BUILDING CODE OF AUSTRALIA & ACCESSIBILITY COMPLIANCE ASSESSMENT REPORT

ALTERATIONS AND ADDITIONS TO AN EXISTING MIXED USE BUILDING

19-23 THE CORSO, MANLY

REPORT NO. ► 11784.1 Rev 2.0

GROUND FLOOR PLAN - PROPOSED

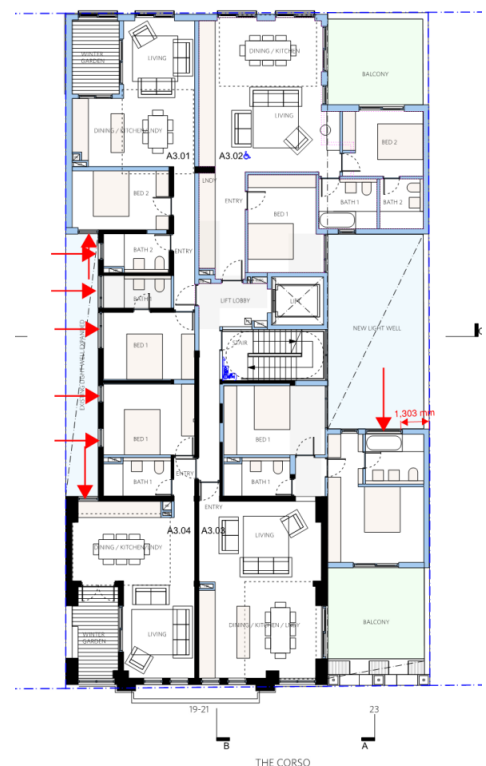
BCA Clause	Deemed-to-Satisfy Provision to be addressed
C2.7 Separation by Fire Walls	<p>The separation of building will utilise a horizontal fire wall which does not comply with C2.7(b).</p> <p><i>It is recommended this is addressed by a Fire Engineered Performance Solution.</i></p> 
C3.2 Protection of openings in external walls	<p>The following openings are located within 3m of the side boundary and not protected in accordance with C3.4.</p>
